# Economic and Social Council

##### **Standardization of technical and safety requirements in inland navigation: Recommendations on Harmonized Europe-Wide Technical Requirements for Inland Navigation Vessels (Resolution No. 61, revision 2)**

### **Proposals for amendments to Recommendations on Harmonized Europe-Wide Technical Requirements for Inland Navigation Vessels (Resolution No. 61): technical requirements for ramps for inland navigation vessels**

**Transmitted by the Government of the Russian Federation**

Figure 10.6.1.8-1

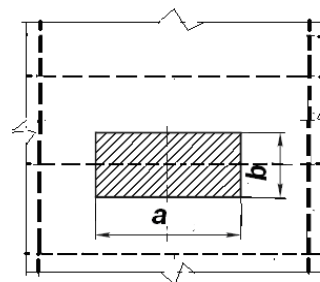
The design position of the wheel footprint for the purpose of calculating the strength of the plate is shown in figure 10.6.1.8-1 and the strength of the stiffener in 10.6.1.8-2.

Dimensions of the loading platform, m, when vehicles move along the beam framing (see fig. 10.6.1.8-1 and fig. 10.6.1.8-2) are determined by formulas:
